Title:	Proposed Great Wolf Lodge, Chesterton, Bicester	Date Approved:	August 2022
Discipline:	Civils	Author:	Paul Davis
Note Ref:	2180501-EWP-XX-ZZ-TN-C-0006

This technical note has been prepared in response to the Lead Local Flood Authority (LLFA) comments on Condition 16 of application number 22/01815/DISC dated 19.07.22.

Catchment plan and updated below ground drainage drawings

BELOW GROUND DRAINAGE NOTES

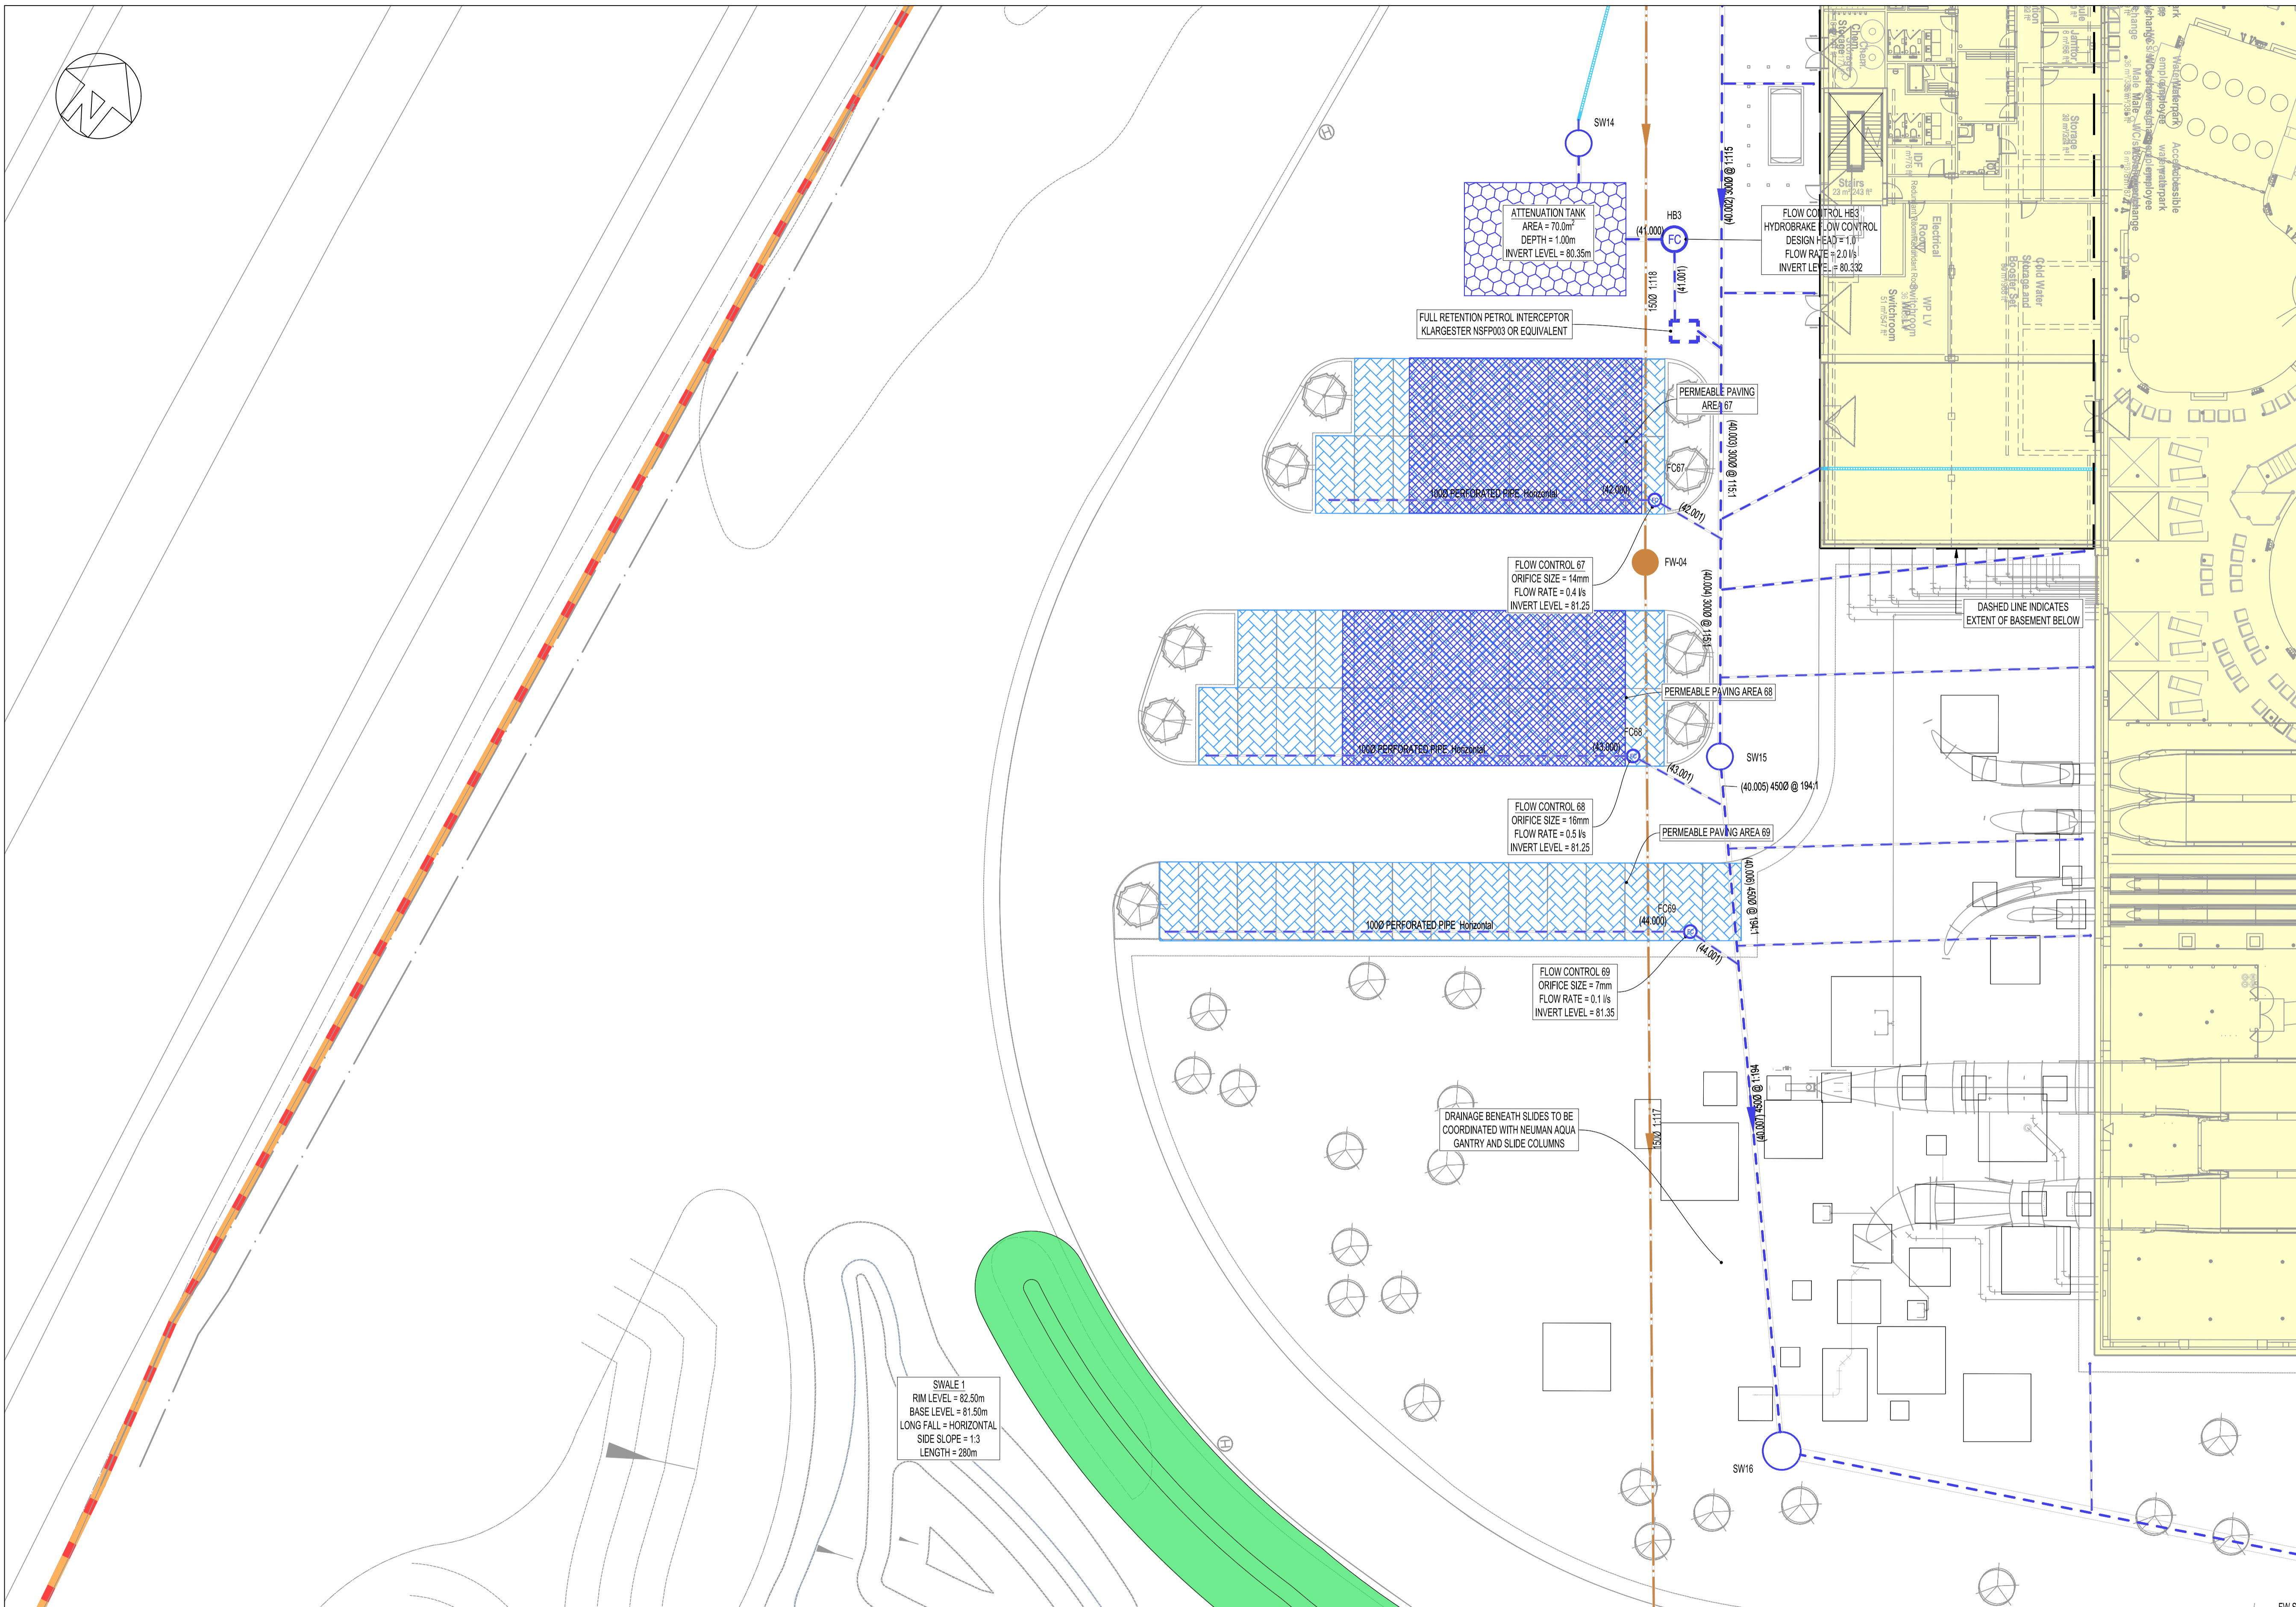
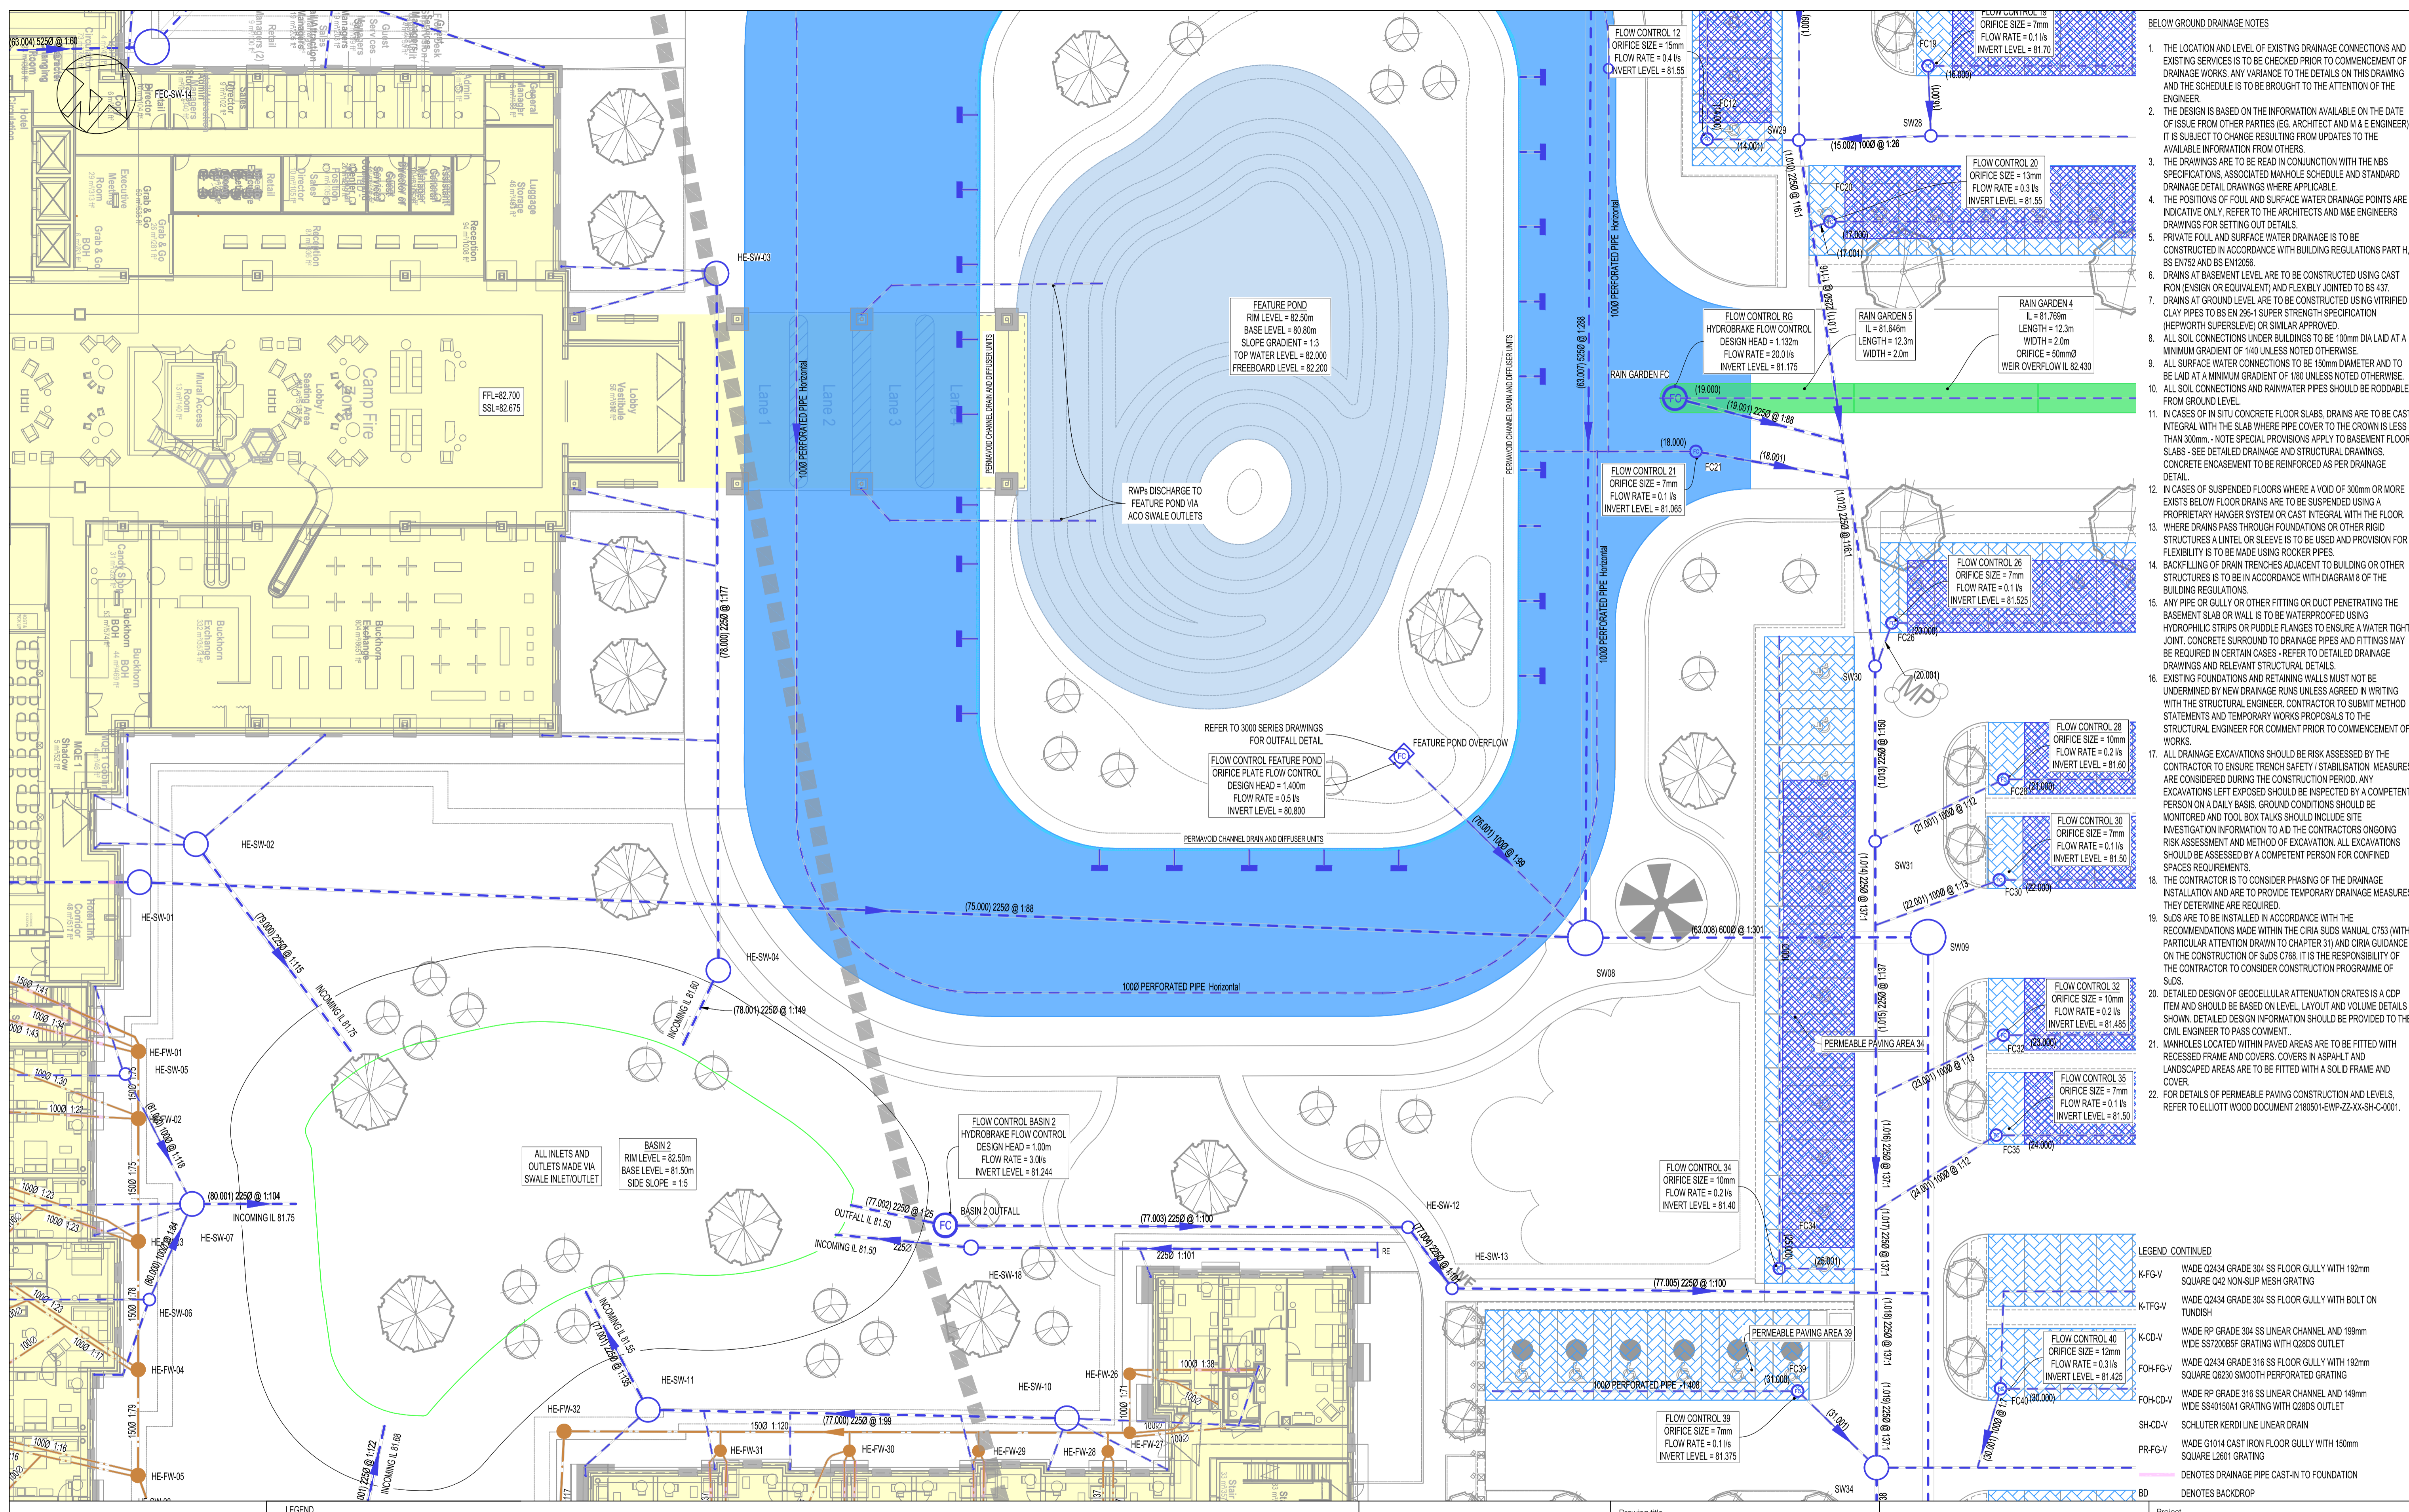
b) Provide surface water catchment plan, clearly showing the extent of the area and stating the area. Ensure all SuDS features are labelled on the drainage strategy drawing and read in line with the calculations.

A catchment plan has been prepared, in addition pipe numbers have been added to the below ground drainage drawings, these drawings are presented in **Appendix A** of this report.
